CHANGE ORDER REQUEST

No. **001**

Date 6/25/2018
Project Name **Electrical for CNG**
Project # **190205**
Owner's Project #: _____
Contract Number: _____

ELECTRICAL SITE PLAN, SINGLE LINE DIAGRAMS AND LOAD CALCULATIONS

SINGLE LINE DIAGRAM AND LOAD CALCULATIONS NTS 3

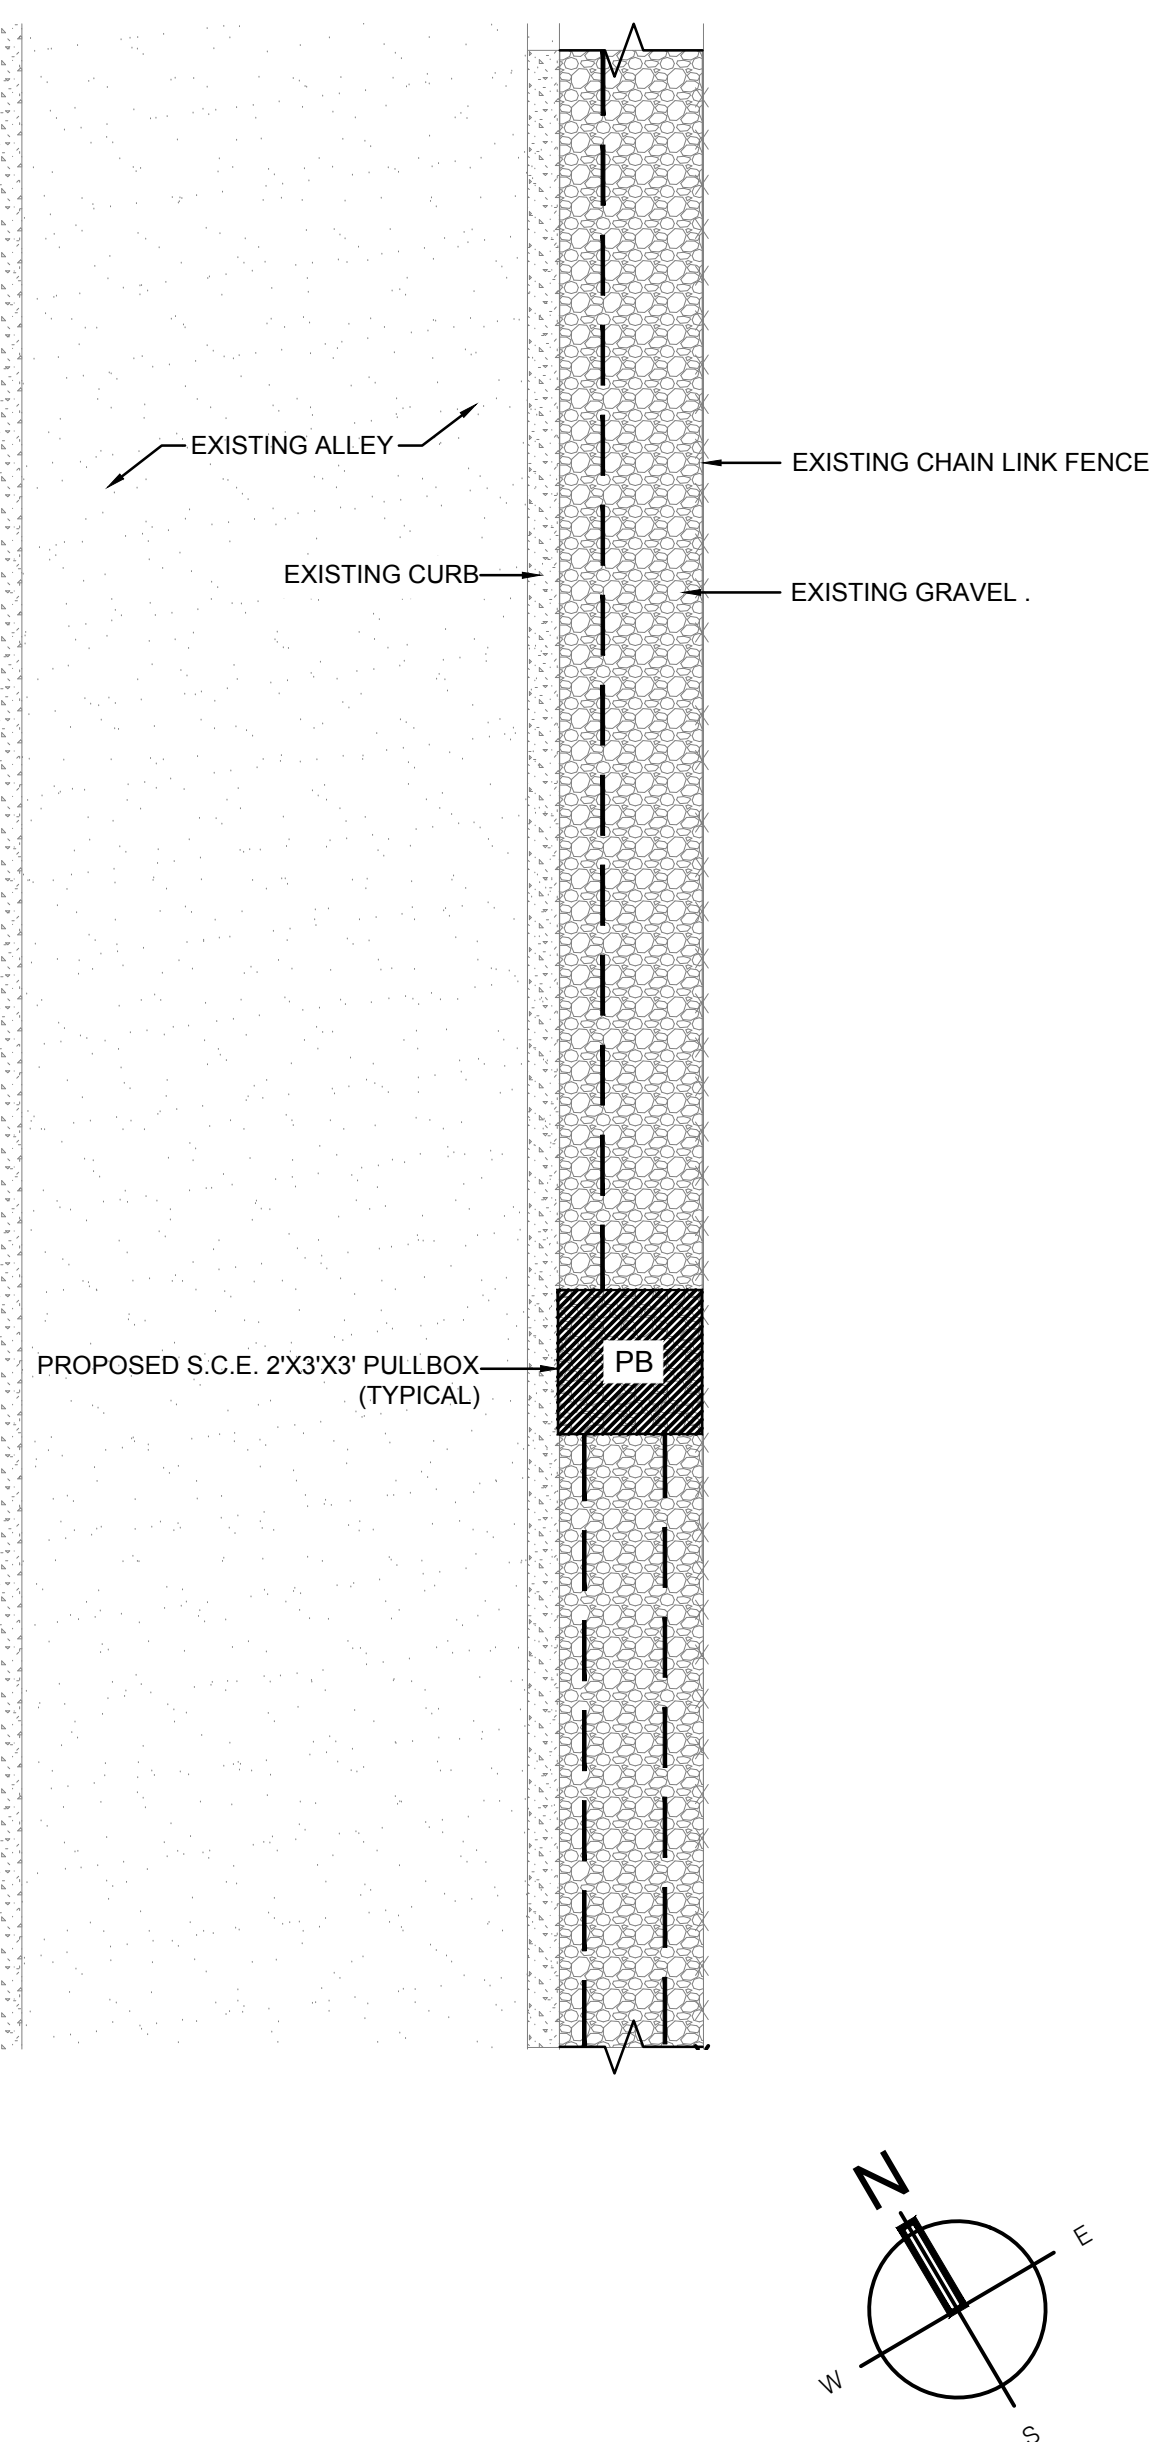
3.3	Per Plansheet E1.00, detail 3 - Please confirm that a new pullbox is required to intercept the transfer switch for the existing generator. At the site walk, we understood that the new metering switchboard is to back feed the existing switchboard not the generator alone?	Response: For the existing generator, No pullbox is required, however a new pullbox is required to connect the new secondary conduit to existing conduit as shown on single line diagram	03/07/2019 11:21 AM (Pacific)

E1.00

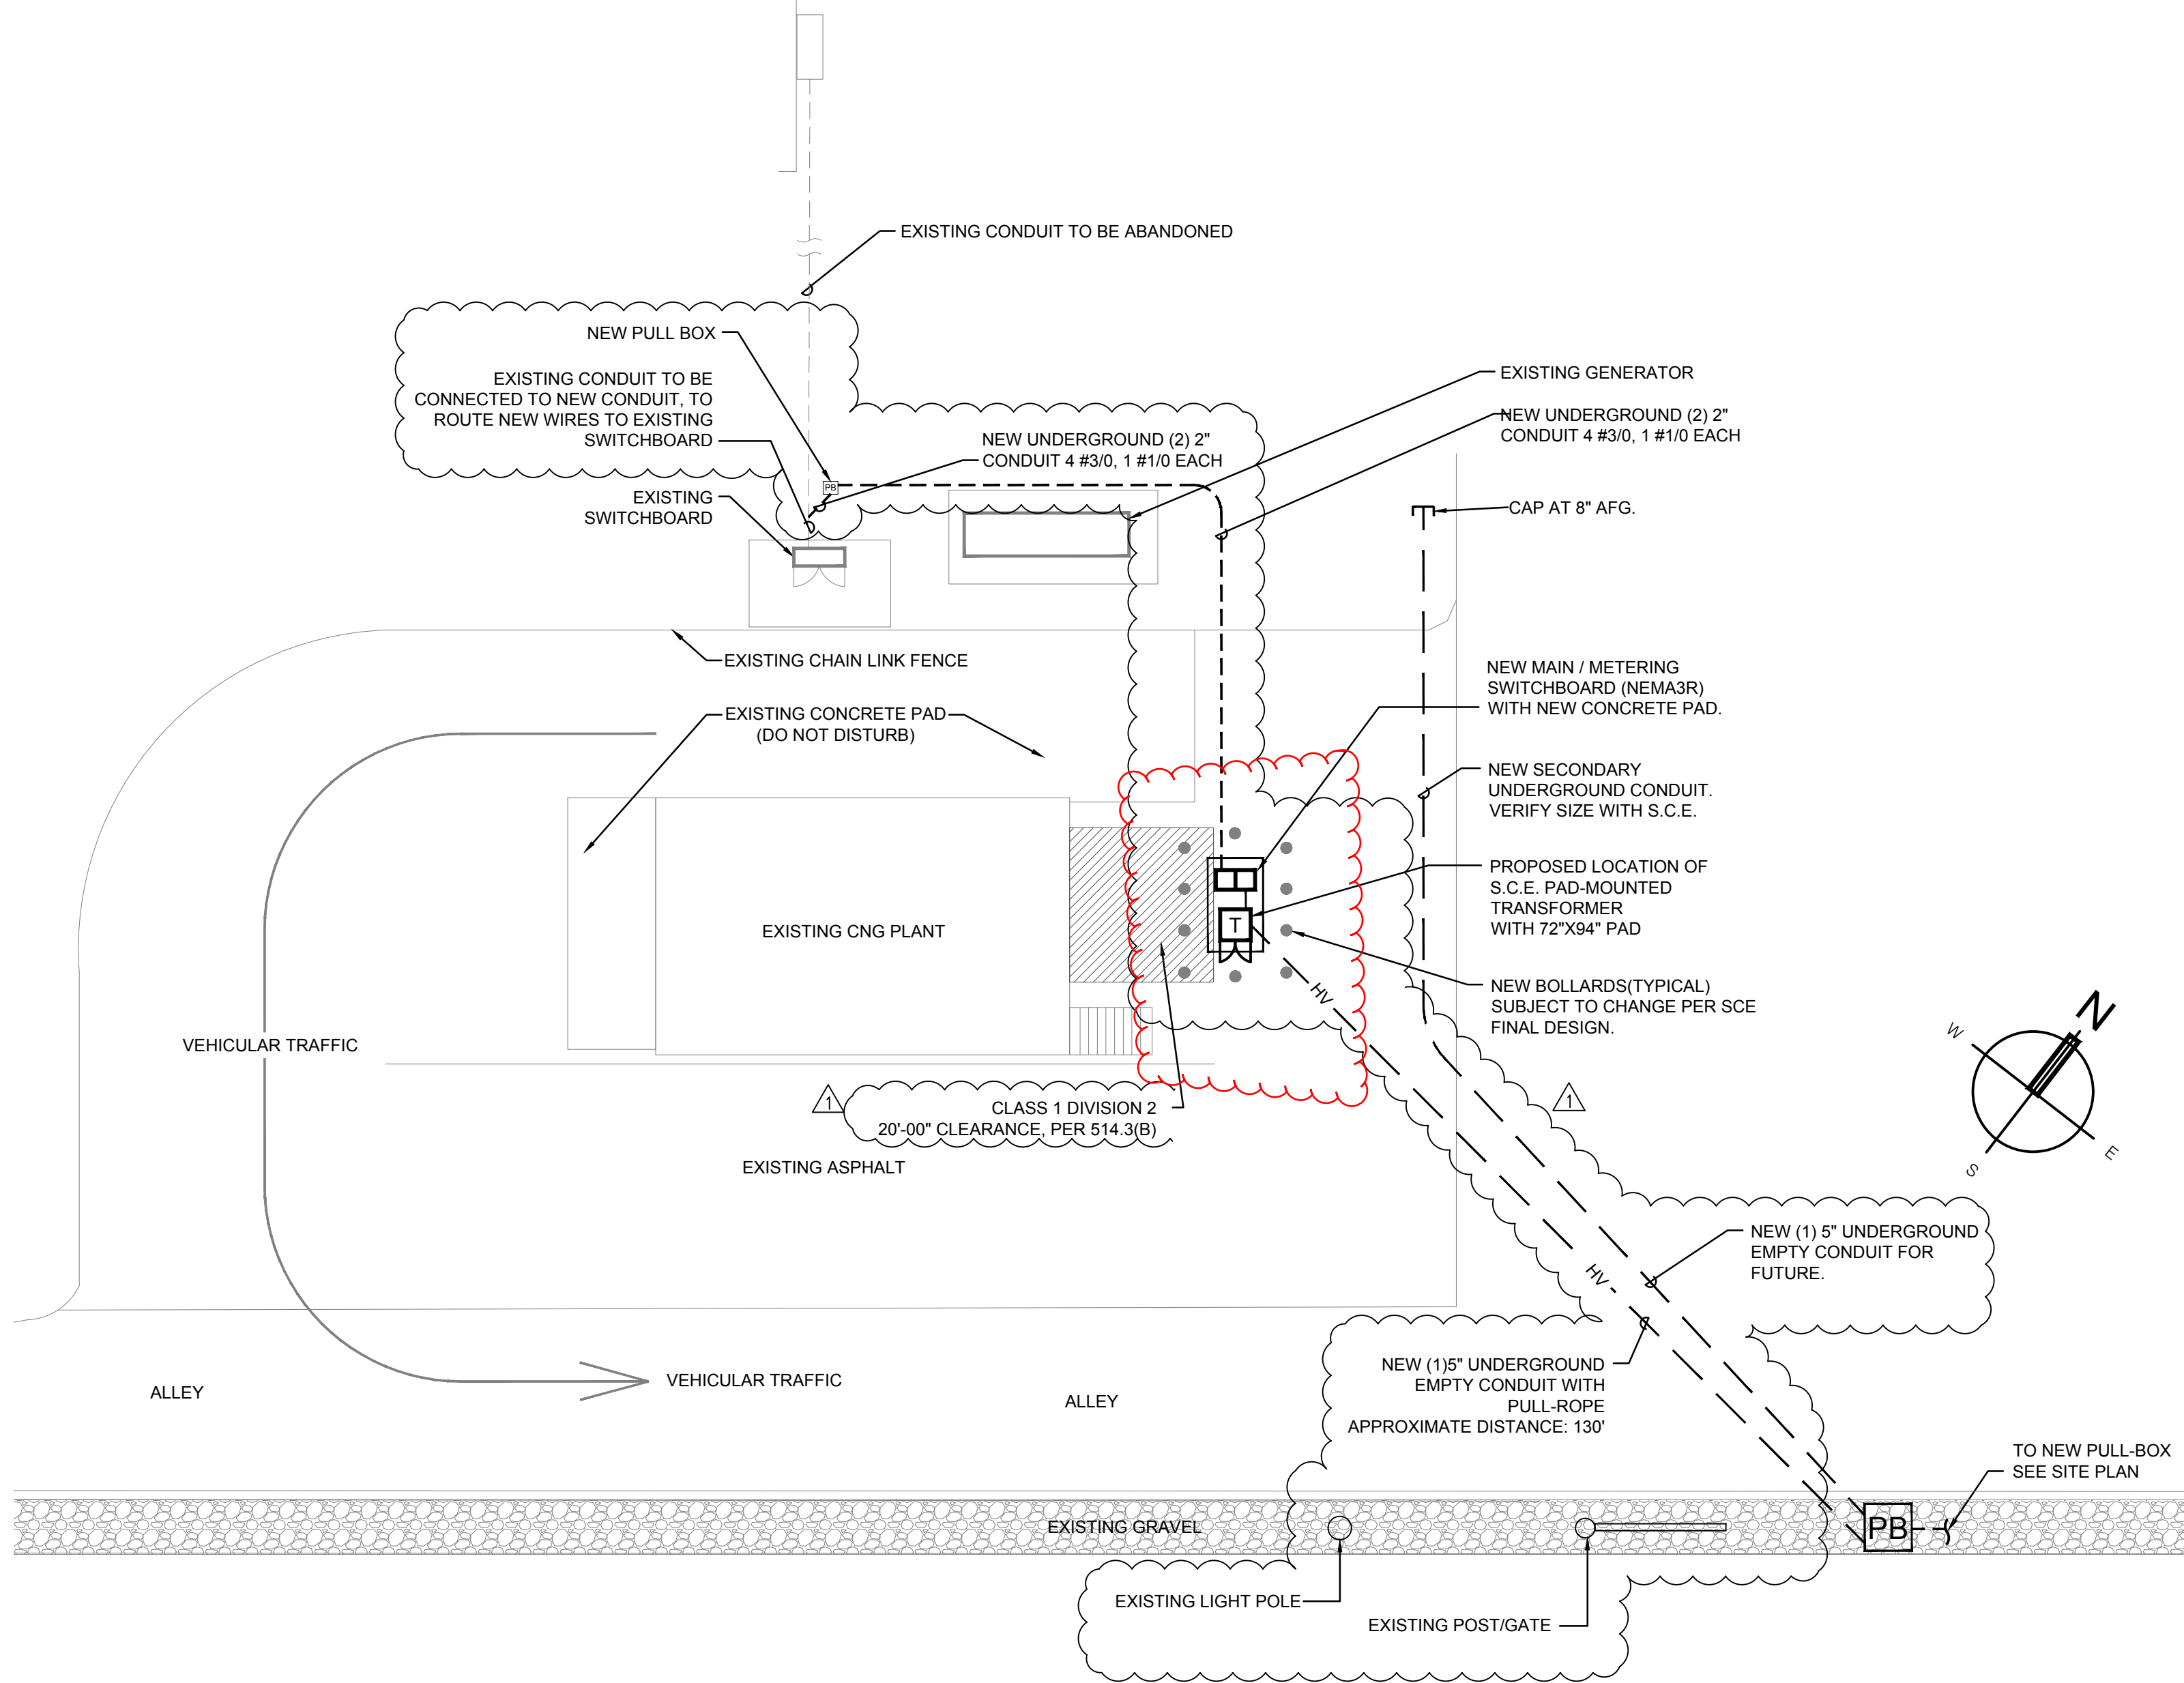
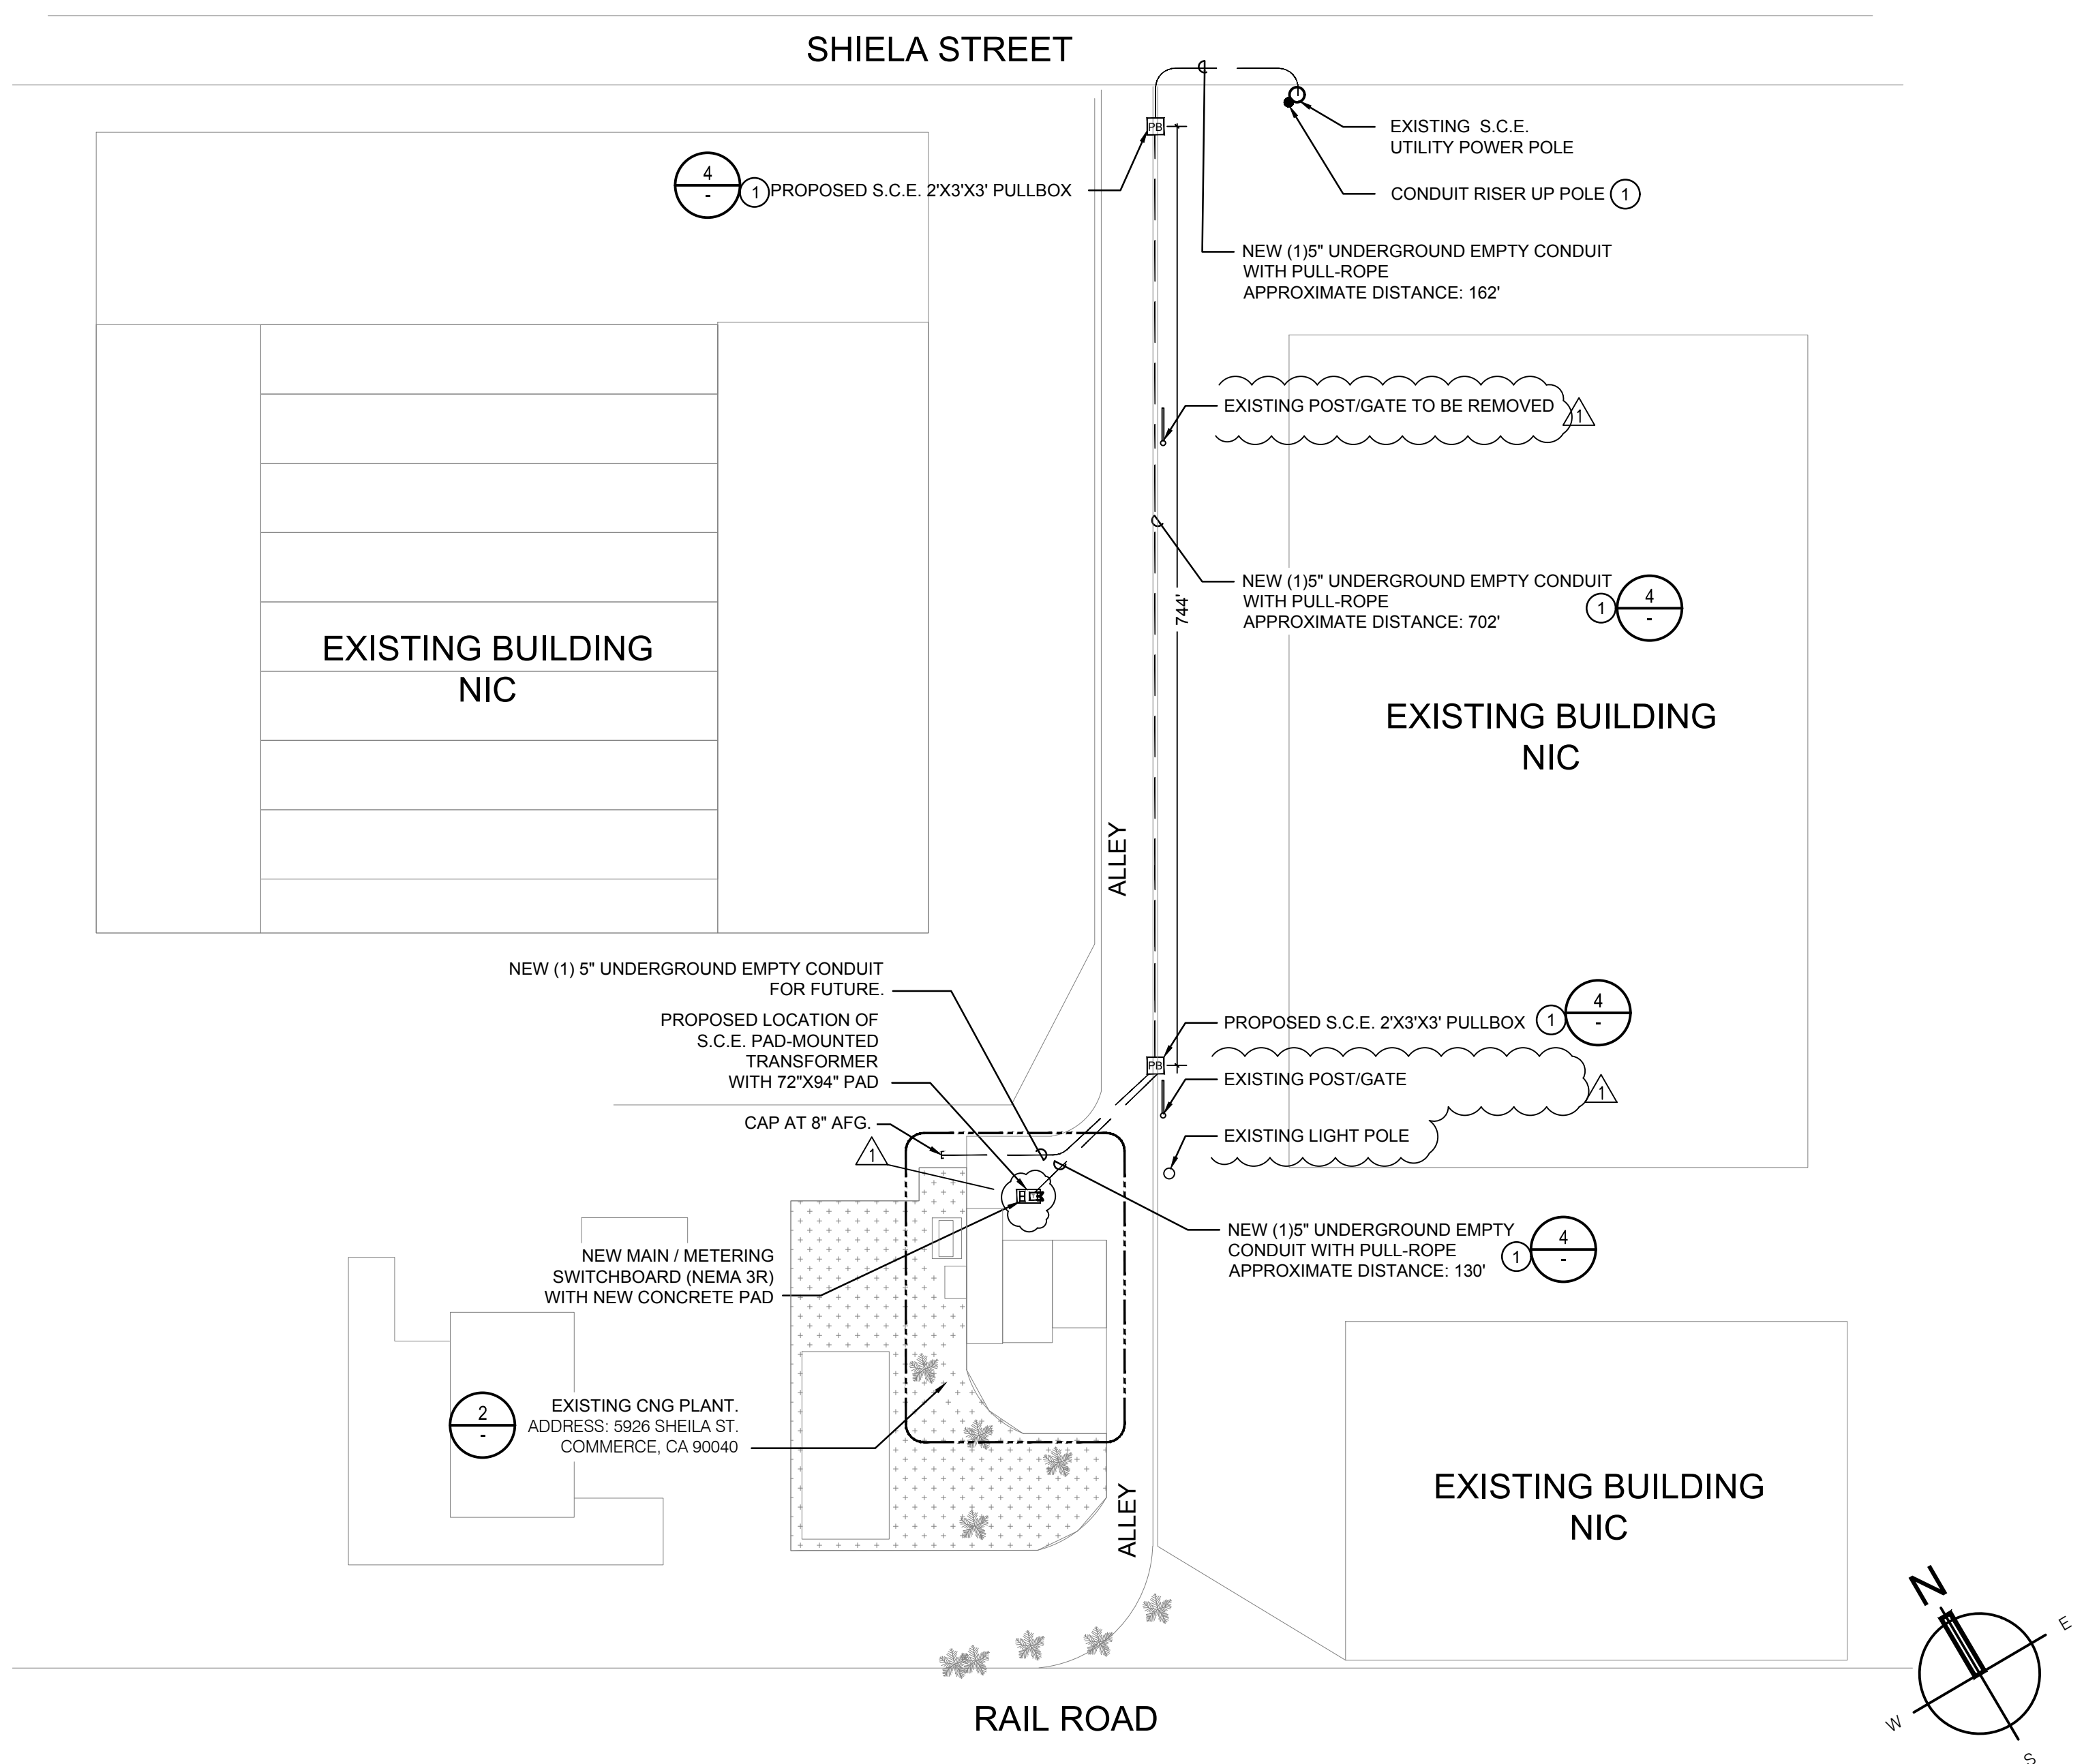
Provide labor and material to form, pour 9 additional bollards as requested by the SCE inspector. Plans called for 10 bollards, 19 bollards were installed.

3.1	Per Field visit, the existing trench layout area has (2) 8" gate post and one underground monitoring well. Please advise if these are to be removed and abandoned.	Response: Remove the post and trench away from the monitoring well (See revised E1.00 dated 3/6/19).	03/07/2019 11:21 AM (Pacific)

3.2	Plansheet E1.00 calls for a new pullbox at the existing switchboard. Please provide pullbox size.	Response: 16"Hx16"Wx4"D. The plan shows new conduit will terminate at switchboard but it will terminate at the new pullbox (See revised E1.00 dated 3/6/19).	03/07/2019 11:21 AM (Pacific)

3.4	SCE plans show 10 bollards around the slab-box while plansheet E1.00 shows 7 bollards. Please confirm quantities.	Response: Refer to SCE plans sheet 3 of 3 for protective barrier details also (See revised E1.00 dated 3/6/19).	03/07/2019 11:21 AM (Pacific)
